Appendix A Consultation Feedback Report for Past Engagement

Consultation Feedback Report

Project Background

Option 1: Replacing the <5 year remaining life seawall

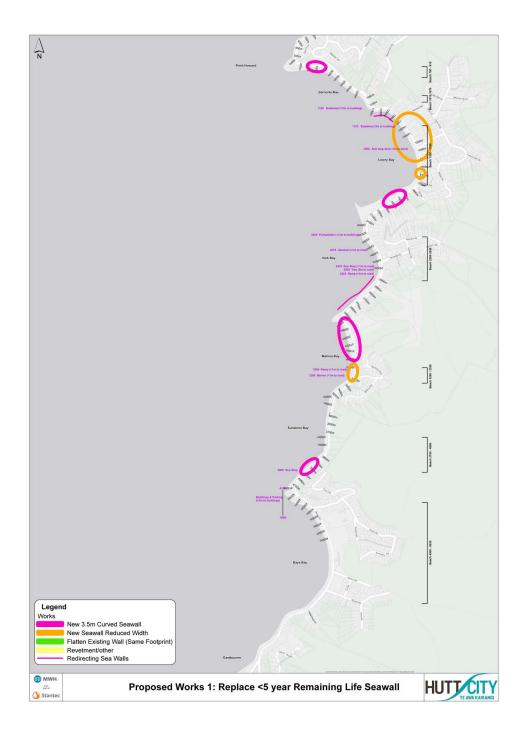
People told us: This option is seen as a short-term fix that people won't use. People mentioned that this type of upgrade should be covered under existing maintenance budgets.

"Why bother? Will not make enough change. Spend a little more. Achieve multiple benefits."

Option 2: 1.5m width

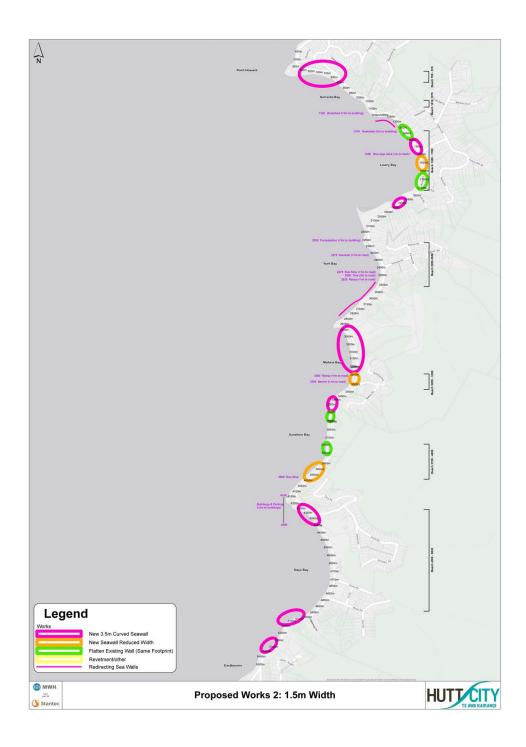
People told us: This option is too narrow, and although it would be better than what exists at the moment, it wouldn't cater for both cyclists and walkers.

"Insufficient improvement not enough room for bikes, walkers, dogs and wheelchairs. Not wide enough to get a road sweeper. Not enough separation from road traffic."

Option 3: 2m width

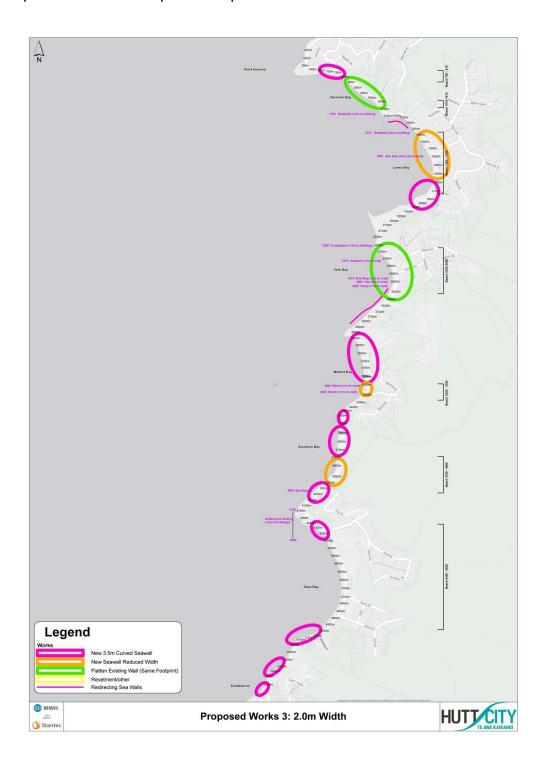
People told us: People viewed this as a minimum, but this option is still considered too narrow.

"A bit tight between cyclists/dog walkers/buggy pushers."

Option 4: 2.5m width

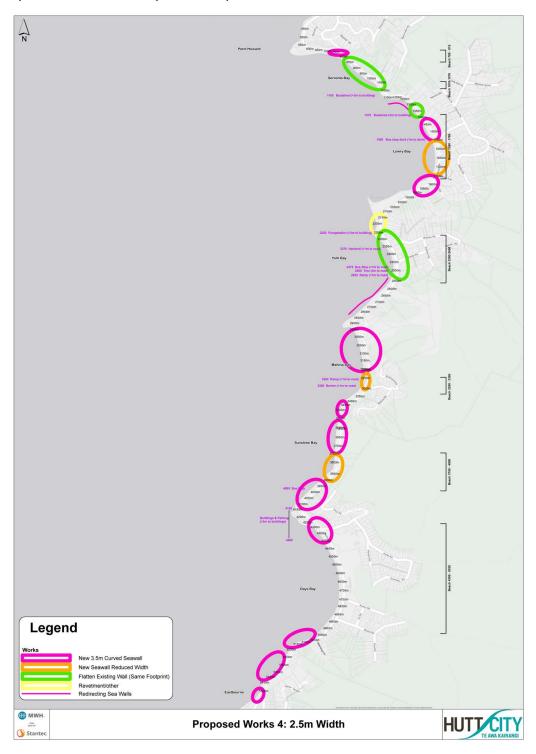
People told us: This option is more acceptable and has support. Concerns around preserving the beaches/trees/boat ramps and the need to include the southern section of Days Bay.

"This seems the most sensible option possibly even the 'Goldilocks' solution not too narrow and not too wide."

Option 5: 3.5m width This option would look to provide a path that is 3.5m wide

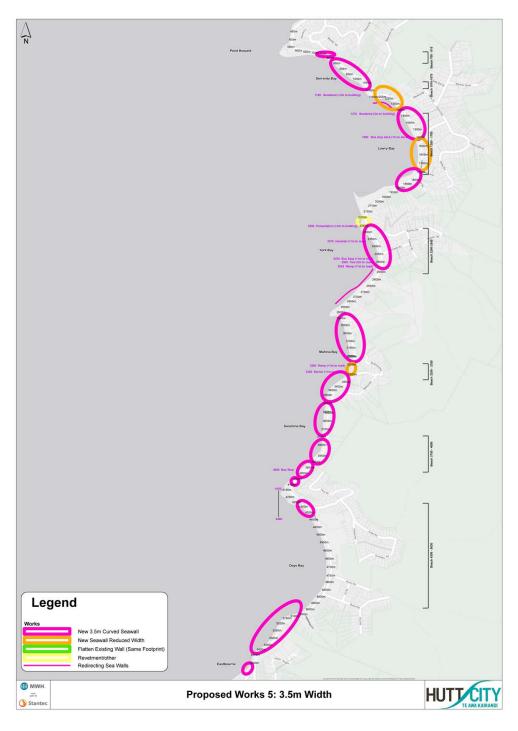
People told us: This option is widely supported. People see this as a long-term valuable asset. The idea of 'do it once, do it properly' comes through. There are some questions about sea-level, keeping the beaches intact and the cost.

"As wide as possible = safe and useable as possible."
